REMARKS

The specification has been objected to under 35 U.S.C. 112, first paragraph and 37 C.F.R. 1.171, for the reasons stated on page 2 of the current Office Action dated January 19, 2005. This objection is respectfully traversed for the following reasons.

Enclosed are nine (9) Annotated Drawing Sheets, wherein various corrections have been denoted in red ink or red highlighting. Also enclosed are thirteen (13) drawing Replacement Sheets.

Figure 5

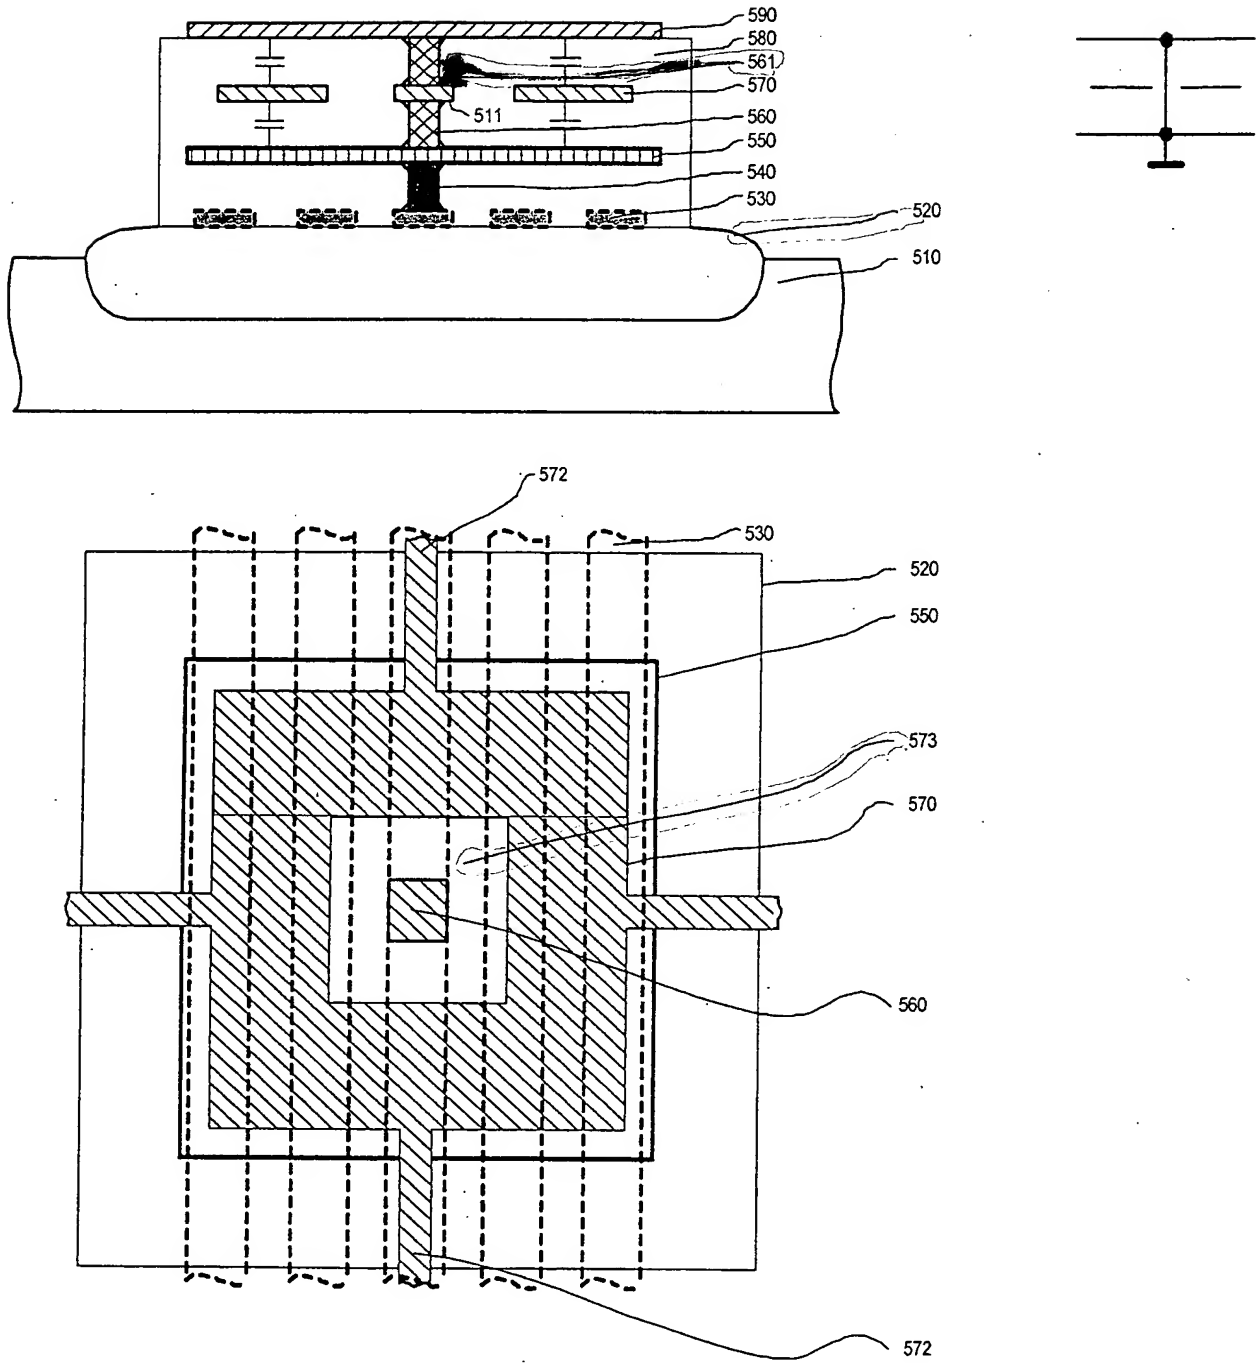
The drawings and specification have been variously corrected in view of the issues raised by the Examiner. For example, page 7 of the specification has been corrected to describe Metal2 plate 511 as illustrated in Fig. 5. Also, via 561 has been denoted in Fig. 5. In Fig. 8, "T1" and "T4" have been clearly denoted. In Fig. 10, "F" has been clearly denoted. Moreover, the various interconnections, lead lines and connections have been made more clear in the figures.

The Examiner has asserted that the bottom conductive pattern of claims 20, 23, 31 and 34 is not clearly described in the specification with respect to the figures. However, Applicants respectfully submit that the bottom conductive pattern 530 as shown in Fig. 5 for example, is described on page 7, lines 4-6 and page 8, lines 3-6. Also, the bottom conductive patterns as illustrated in Figs. 6a – 6d are described on page 8. Applicants therefore respectfully submit that the bottom conductive patterns are clearly described in the specification with respect to the figures, and that claims 20, 23, 31 and 34 are in compliance with 35 U.S.C. 112, first paragraph.
